Main Wire Harness Replacement

Model: 5680

NOTICE: This instruction bulletin applies to 5680 models manufactured before serial 10551746 (Dec 2011). The new replacement harness is equipped with a 7.5 amp fuse to protect the scrub head lift actuator circuit. The installation of the new harness remains the same as the previous harness with the exception of the following wire connection as shown below.

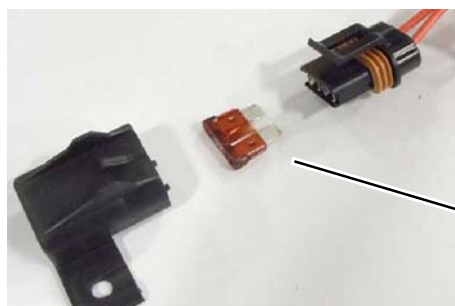
Connect new wire [3D/Orange]
to Main Connector as shown.

New 7.5 Amp Fuse added to the
Scrub Head Lift Actuator circuit.
Replacement Fuse p/n 1016039

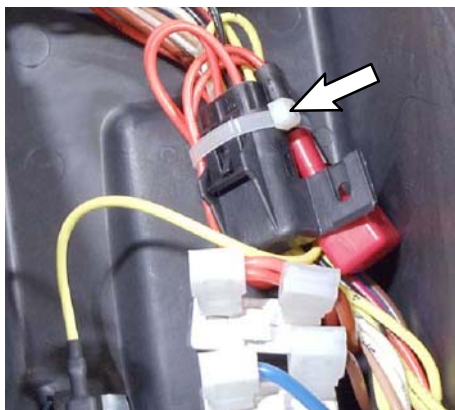
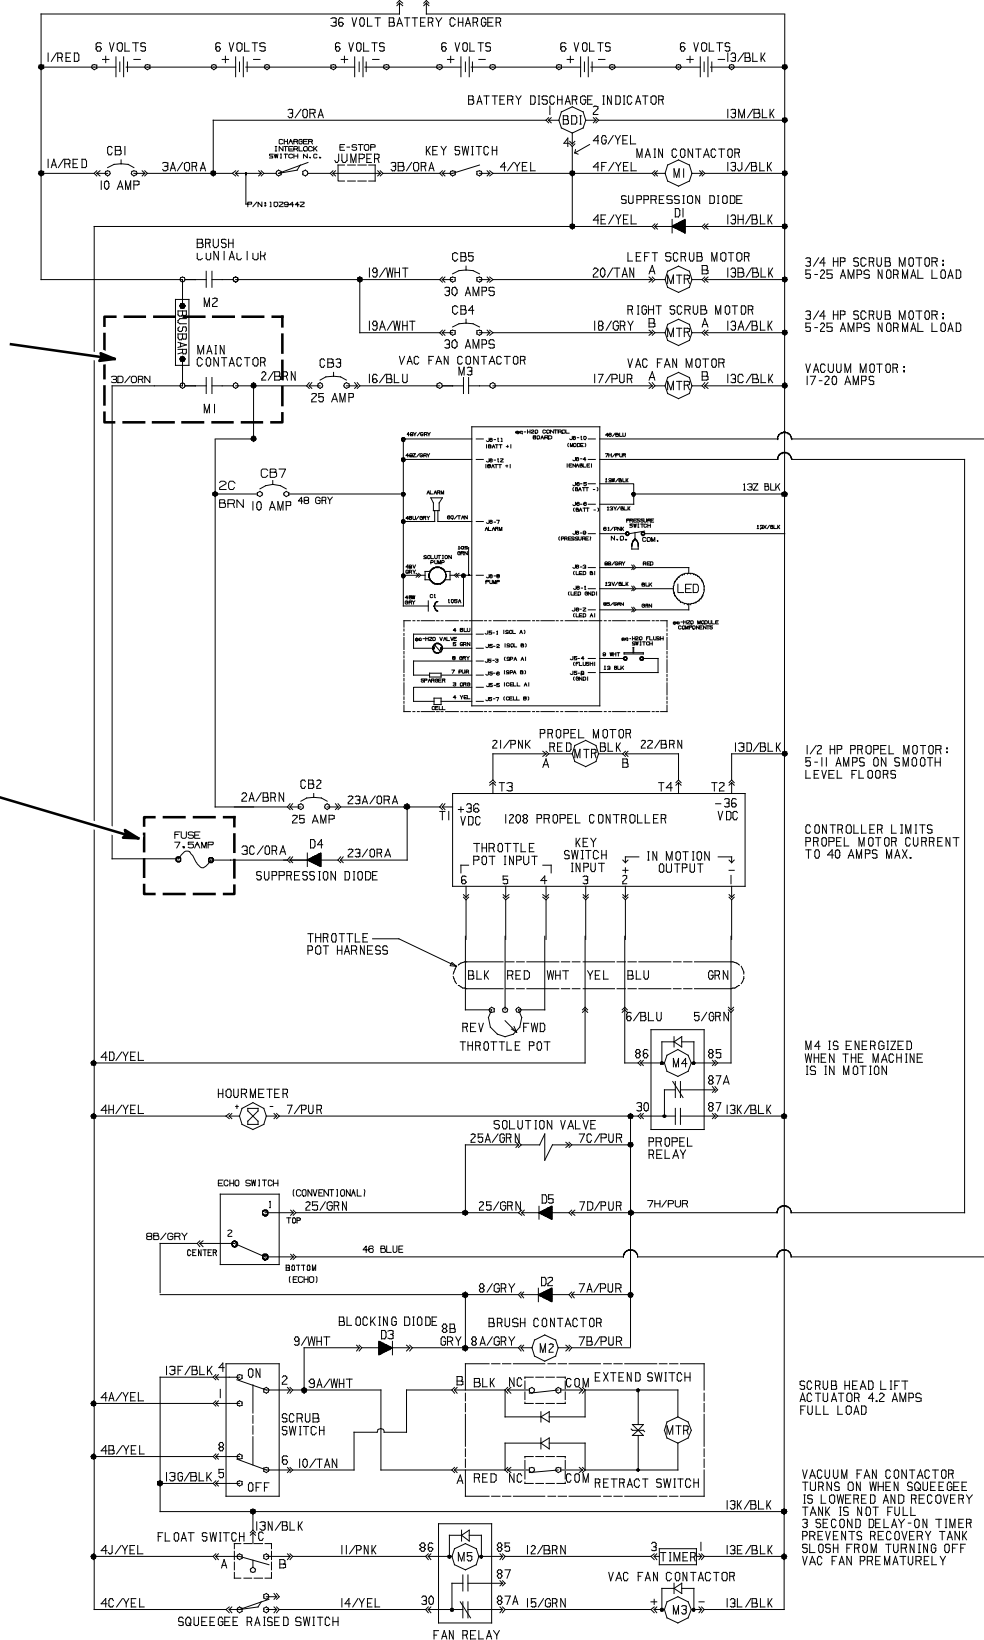
Use a zip-tie to secure the 7.5
Amp Fuse as shown.
